Basic Concept for Smart Meter Specification based on RFC

July 12, 2012

Tokyo Electric Power Company, Incorporated

II. Major Revisions from Previous Specification

〈Communication protocol for route A〉

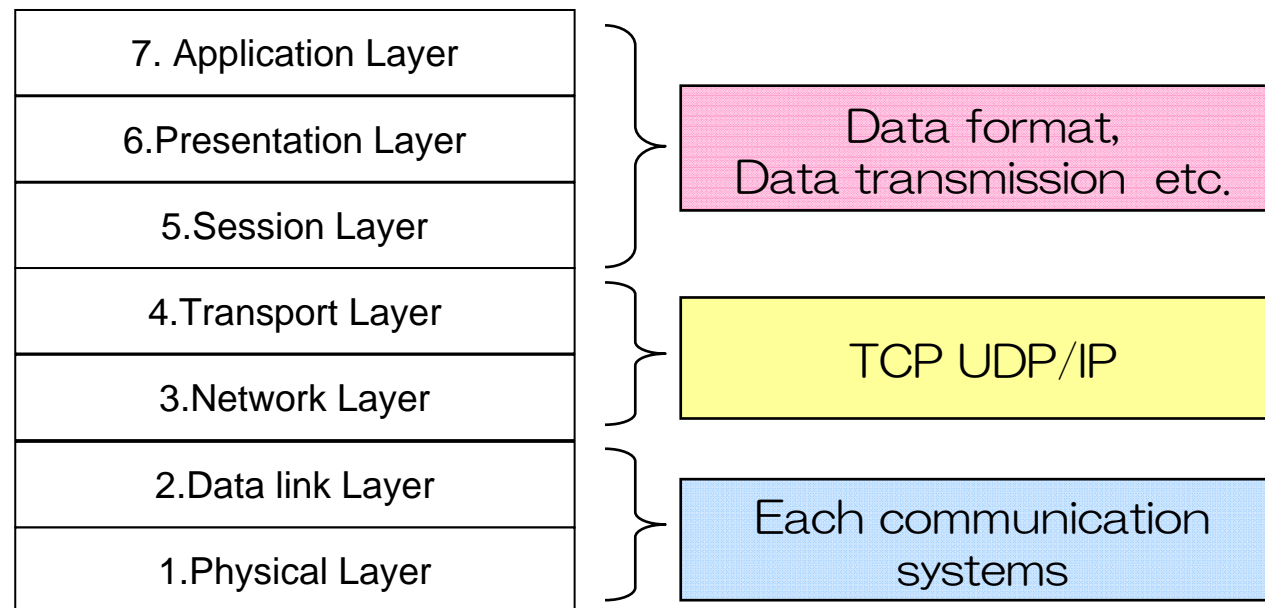
Ⅱ-1. Adoption of International Standards (2) -IP-based network-

■ AMI network (route A) will be IP-based network in principle.

- Adopting IP will enable to separate communication systems (wireless communications etc.) and data transmission (e.g. Standards for meter data structure defined in IEC or ANSI etc.), which make flexible system for future change or expanding function.

Ⅱ-1. Adoption of International Standards (3) -Data format-

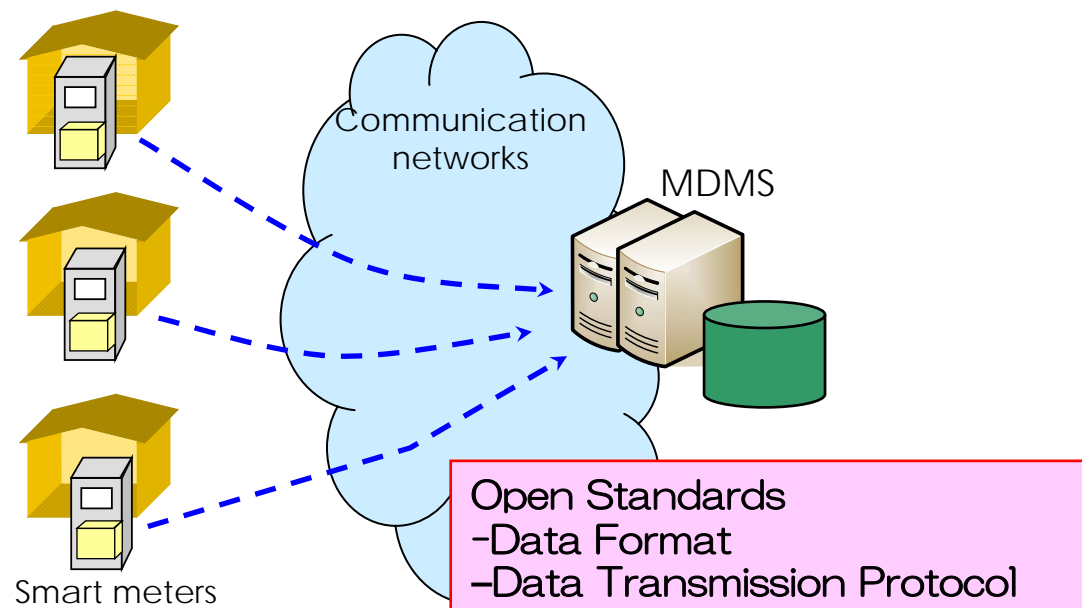
- TEPCO will aim to deploy international standards for metering data format and transmission protocols.
 - International standards will be basically adopted for metering data and transmission protocols considering and comparing development cost and security. However, if TEPCO's conventional specification is admitted to have advantages, TEPCO's specification will be open and become available to enter various vendors.

Ⅱ-3. Functions of Smart Meter (1) -Adoption of integrated structure-

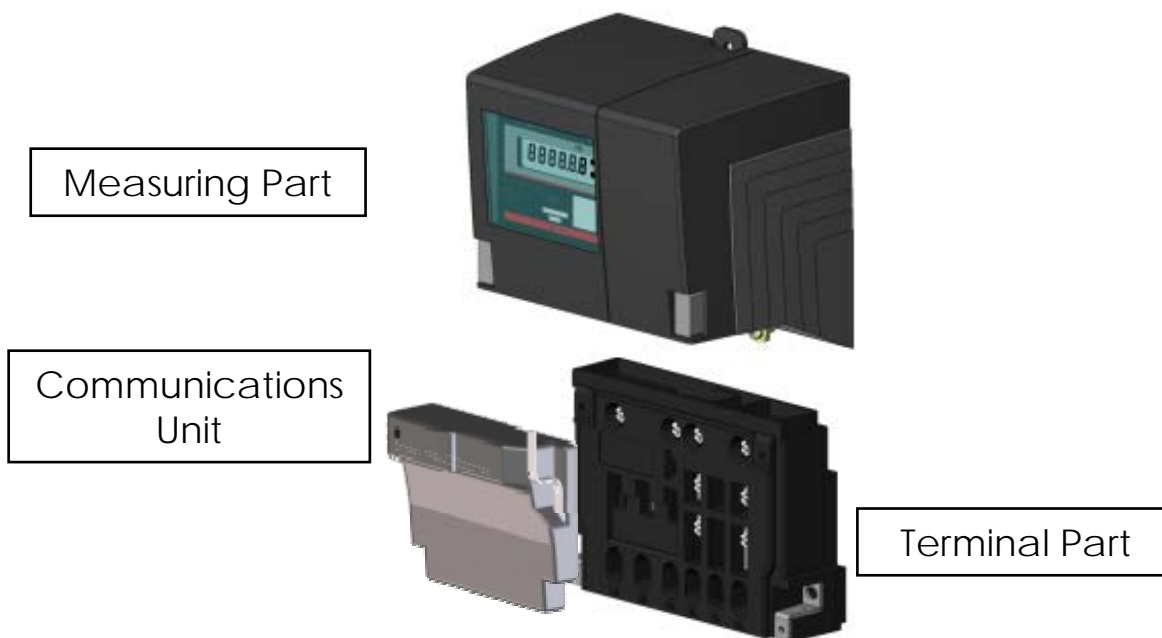
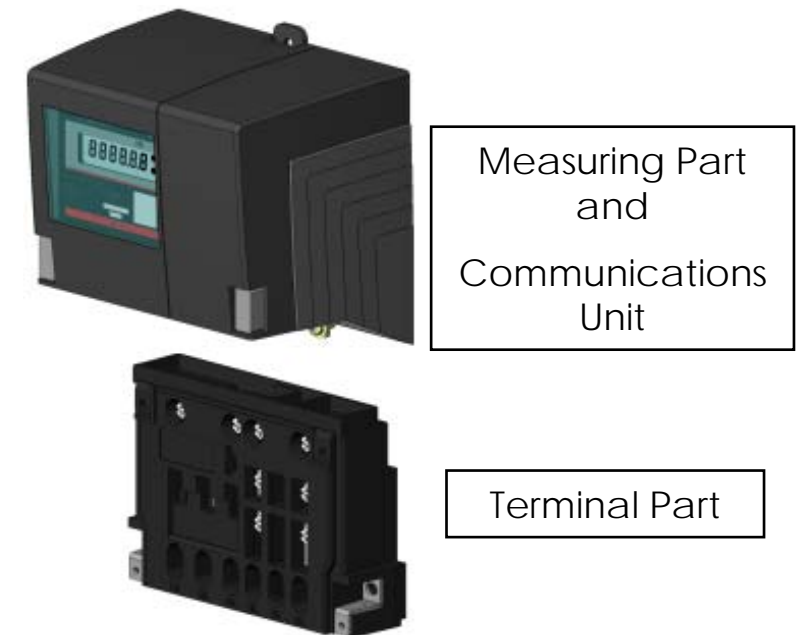
- As for the structure of the measuring part and the communication part of the smart meter, we will adopt integrated structure as well as separated structure, considering possibilities to reduce cost by decreasing the number of parts.

Ⅱ-3. Functions of Smart Meter (3) -30-minute meter reading-

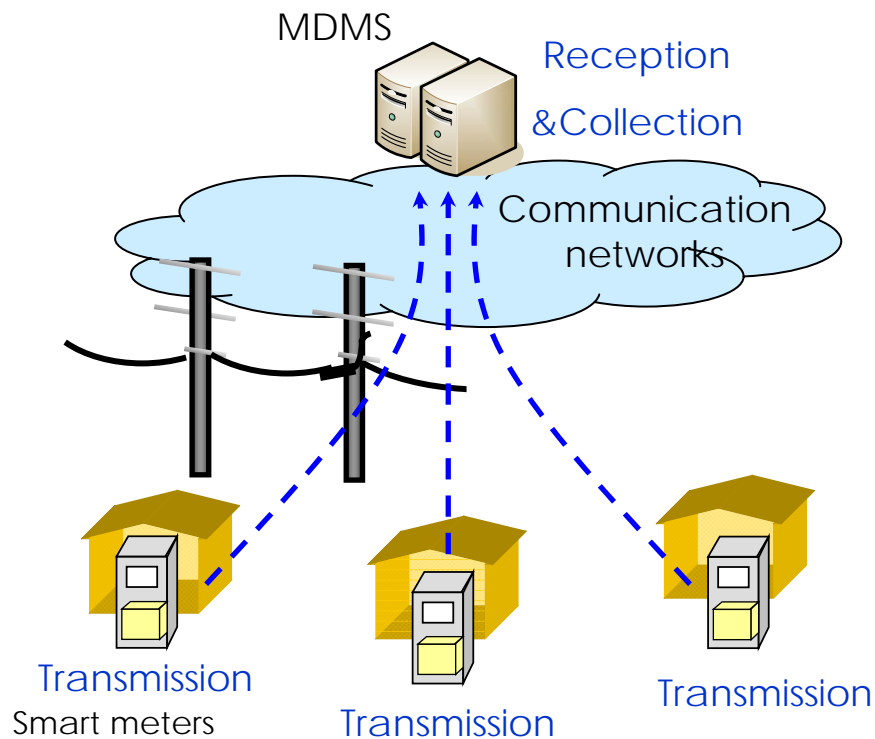
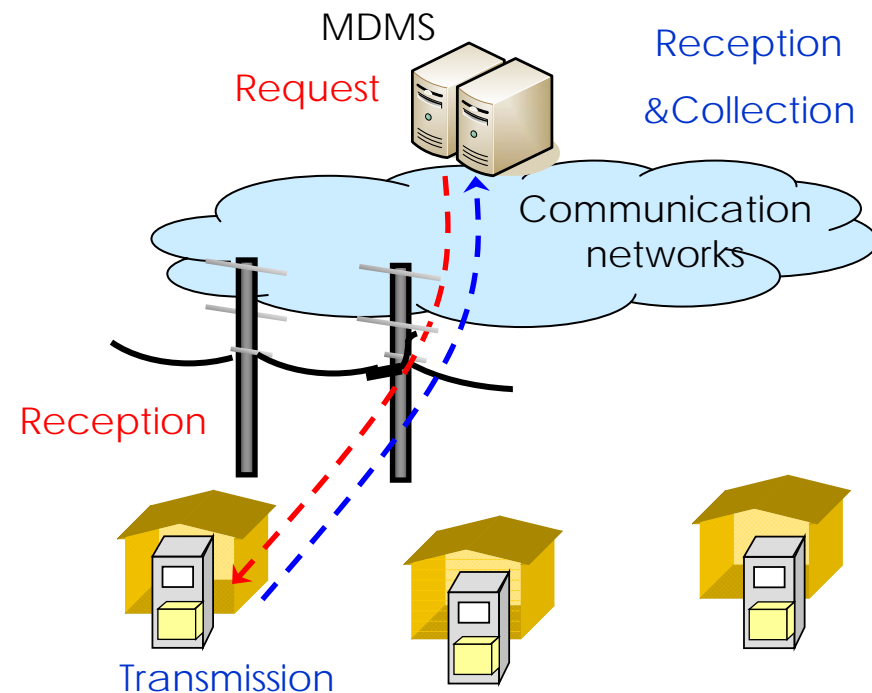
- Smart meters transmit 30-minute meter reading to the MDMS according to designated interval. Transmission interval shall basically be 30 minutes, and can be changed with the expandable function.
- In case of loss of meter reading occurs, meters retransmit the data according to the request from MDMS such as acknowledgement of connection recovery and re-reading order.

Example of DR functions : CPP (Critical Peak Pricing)

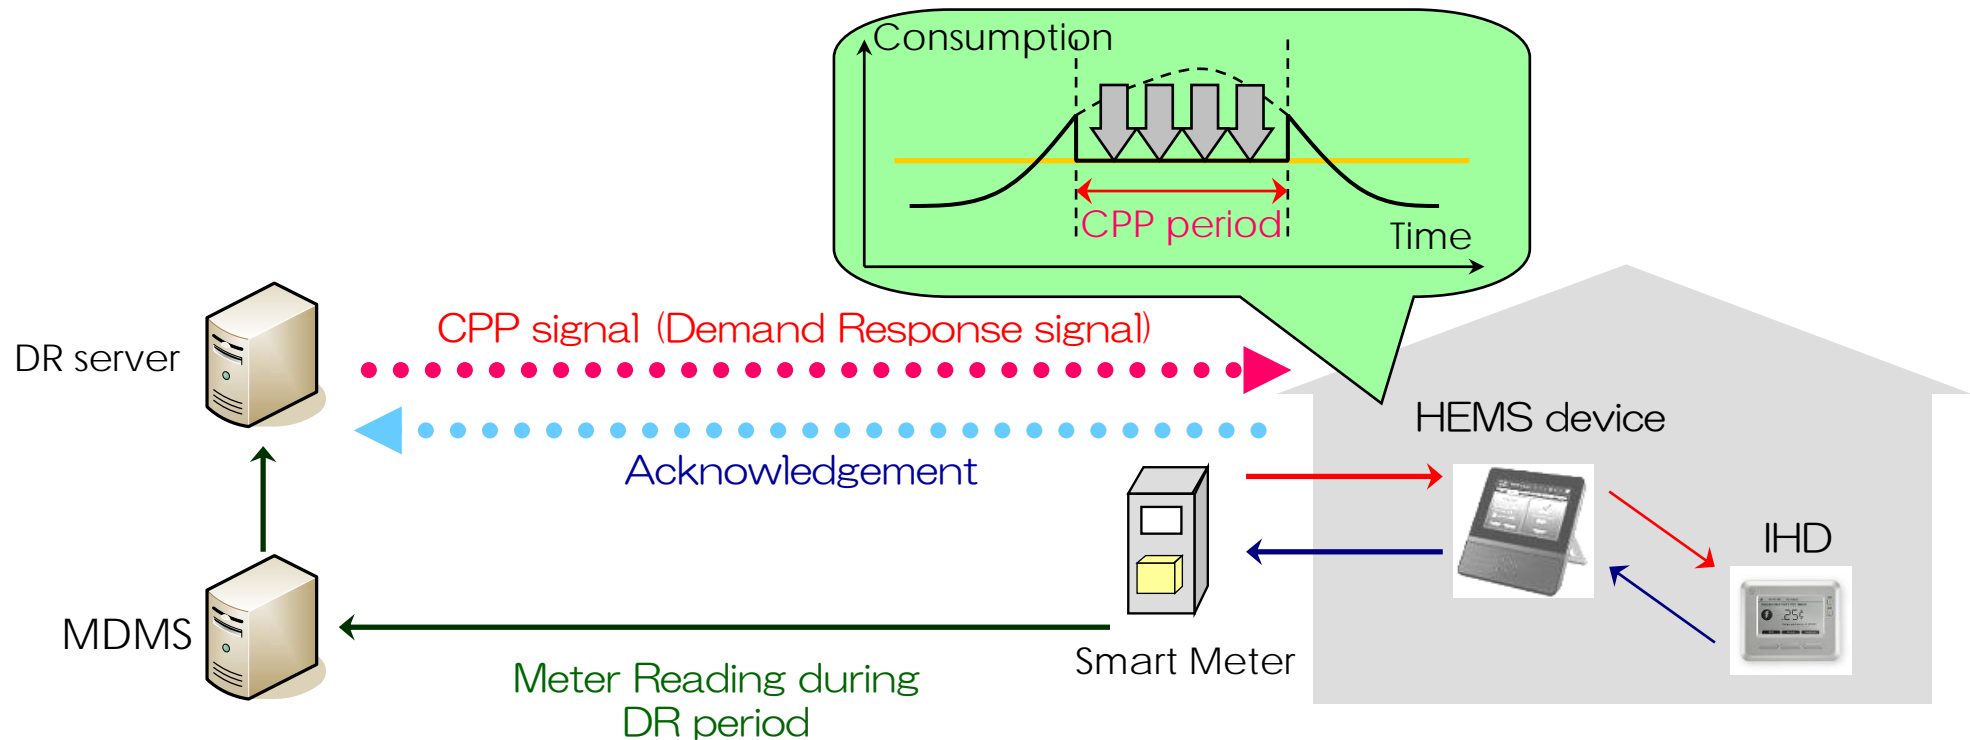
- Smart meters transmit and handle DR signals according to DR services such as CPP (Critical Peak Pricing), PTR (Peak Time Rebate) and so on.
- For newly designated DR services, the interface which can install additional functions will be equipped sufficiently.

< Figure of Service Image >

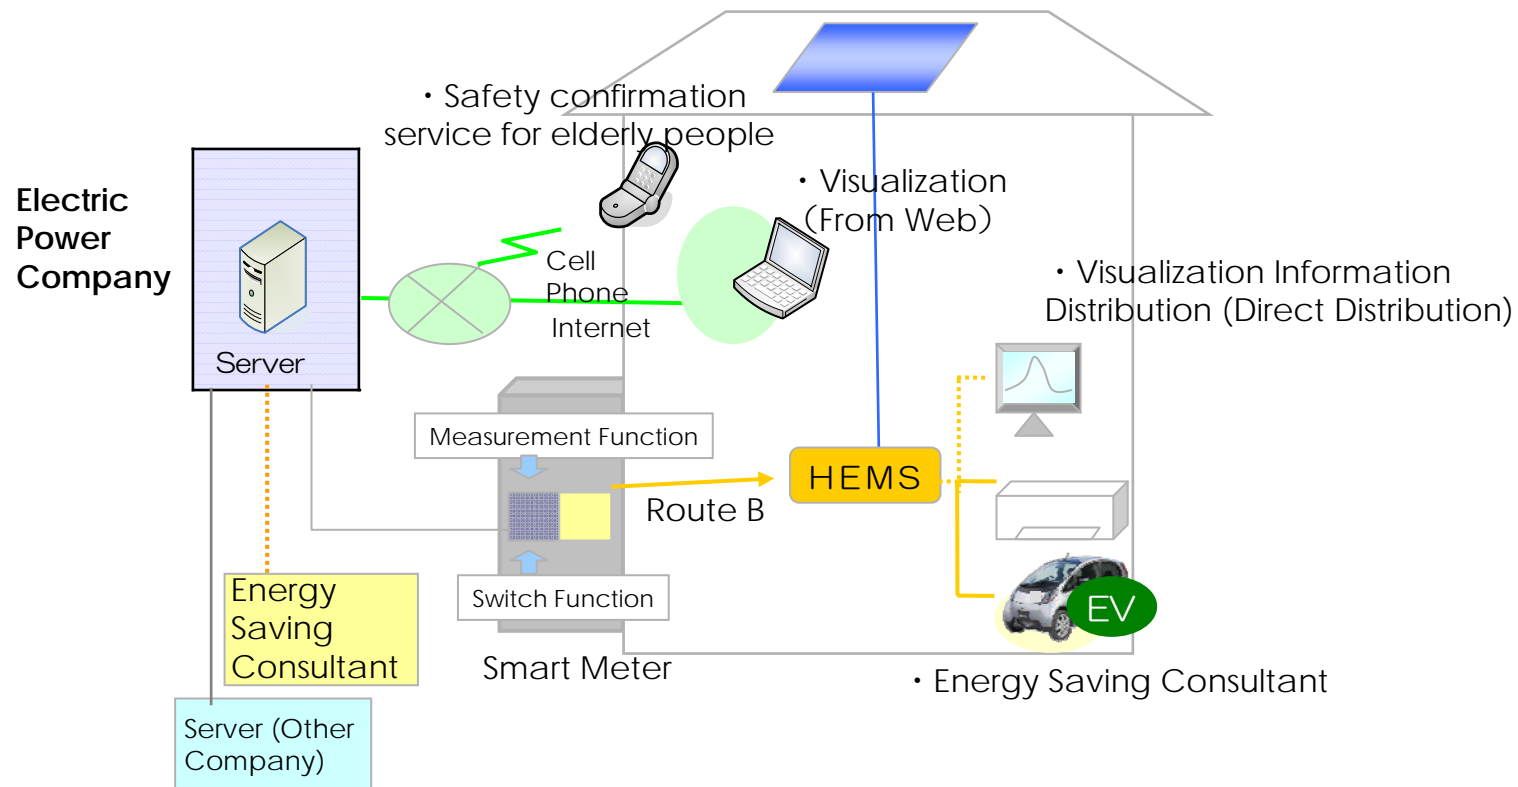
- We assume co-metering with gas and water company, visualization service of electric consumption, nega-watt aggregation business, safety confirmation service for elderly people and energy conservation/energy saving advice as specific services.
- Interface in the smart meter which can additionally implement the desirable functions for future services will be equipped sufficiently. In this case, system architecture must secure fairness for new comers such as new energy business supplier's in the wake of future full electricity deregulation.

Ⅱ-3. Functions of Smart Meter (6) - meter setting & control -

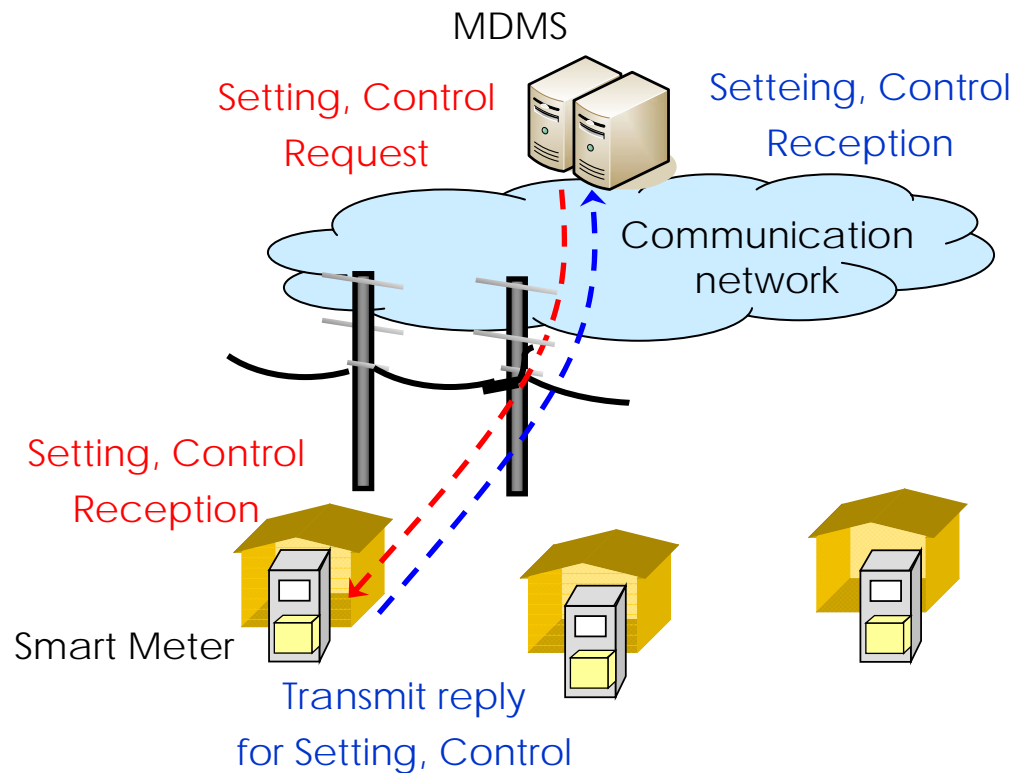
- The smart meter that received the setting and control request data for switch control and others from MDMS executes the requested process, and transmits the results to MDMS.

Ⅱ-3. Functions of Smart Meter (7) - Hand-held terminal communication -

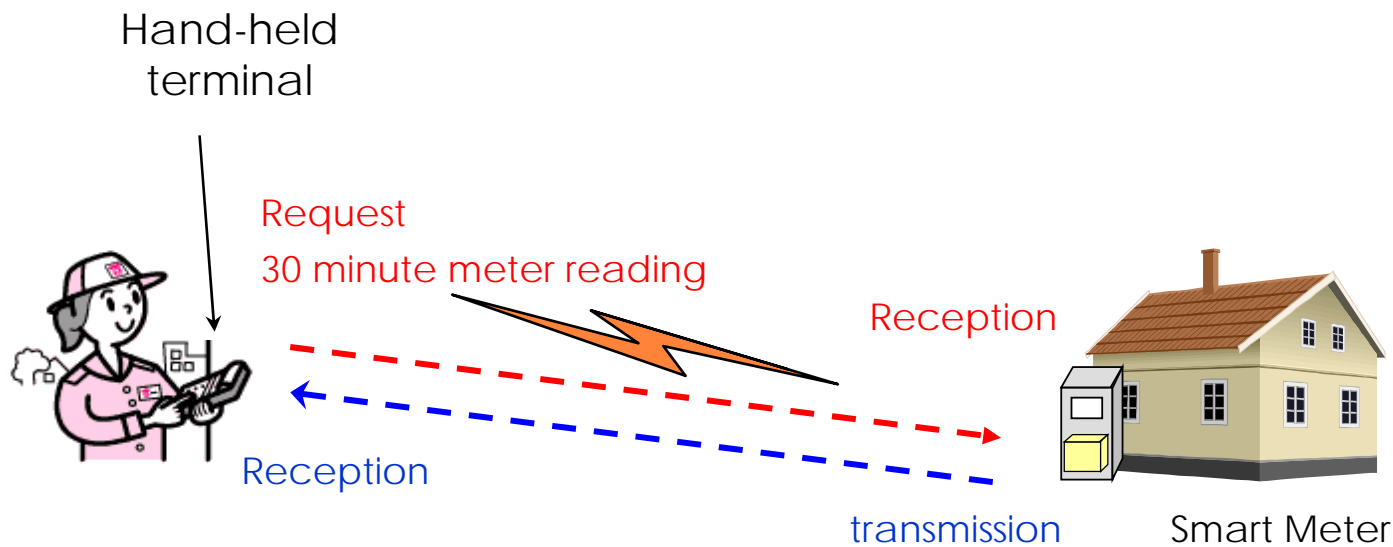
- When communication via the communication network between MDMS and smart meter is not available, meter reading, setting and control can be performed directly by using hand-held terminal on site.

Ⅱ-3. Functions of Smart Meter (9) – Operation and Maintenance -

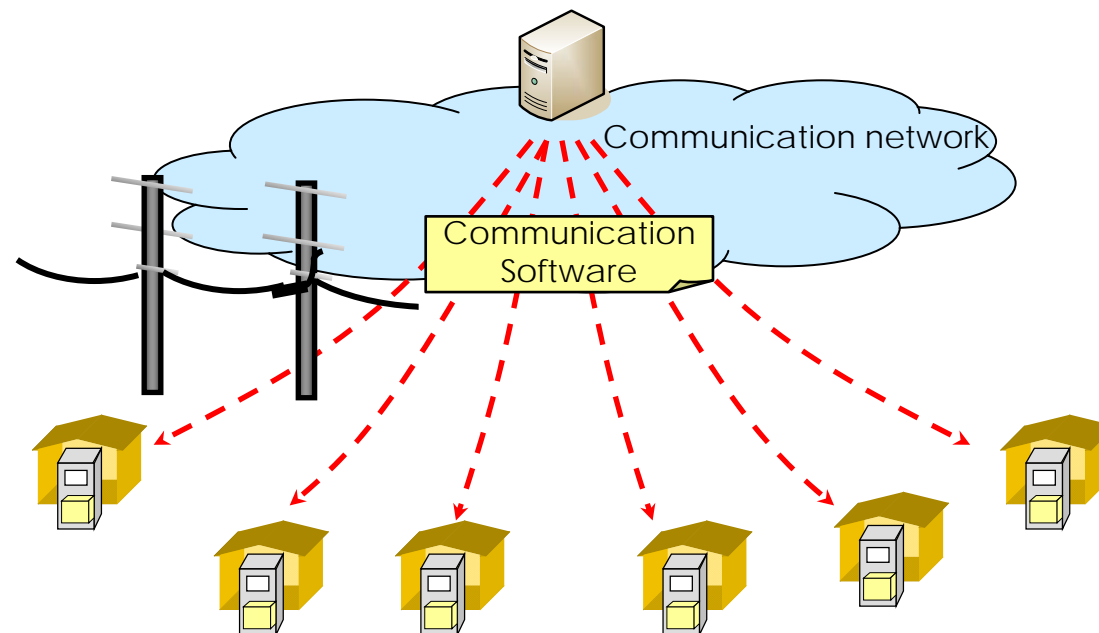
- To manage the large-scale network efficiently and accurately, smart meter automatically transmits facility management information to MDMS.
- To effectively improve the communication software of smart meter, function enhancement for future service and the countermeasure of security depression, the communication software is remotely updated using communication network.
